# Project #20-039 Blue Springs Business Park Located at approximately 150 S. 100 E.

Design Review Permit

Russ Holley, Senior Planner

Staff recommends that the Planning Commission **conditionally approve** a Design Review Permit for Project #20-039, Blue Springs Business Park, in the Industrial Park (IP) zone located at approximately 800 West 1000 North., TIN #05-050-0005; -0021.

Figure 2 shows the proposed site plan

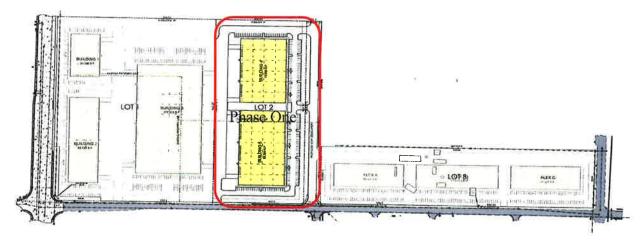
The parking location in the IP zone, and many other zones in the city, indicates placement at the side or rear. In cases where functionality and primary building use present conflicts, the Planning Commission may make exceptions to design issues as per LDC 17.43.080. The Planning Commission needs to make findings that don't compromise neighborhood character and future approvals. The proposal includes semi-truck loading docks and large truck circulation along the entire rear of both buildings, creating conflicts between automobile parking and semi-truck movements. Locating the parking lots adjacent to the semi-truck areas would be challenging and difficult for both vehicle types. Given the layout of the building's floorplans and context of the surrounding large-scale industrial businesses, separating the parking lot and semi-truck loading dock should be a consideration in this situation. Future projects with similar scales and configurations would be treated with the same continuity. As conditioned with the Planning Commission determining the location of parking lots, the project meets the standards in the LDC.

- 1. All standard conditions of approval will be recorded with the Design Review and are available in the Community Development Department.
- 2. The Planning Commission approves parking locations as shown.

Figure 3 shows the street-facing elevations.

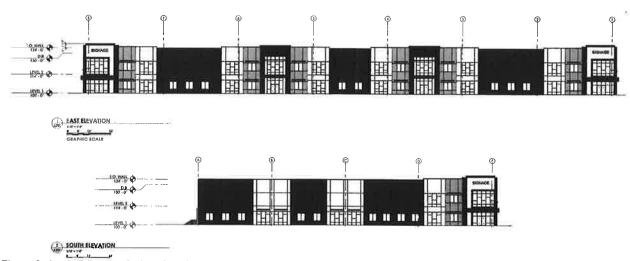
shown with approximately 27% transparency and the south façade along 1000 North is shown with approximately 18% transparency. As conditioned with additional transparency along the south façade, the building design meets the requirements in the LDC.

- 3. The Planning Commission accepts the 27% transparency on the east facades.
- 4. The south façade of building #5 shall have increased transparency or other approved elements similar to transparency to equal 27% of the facade area.
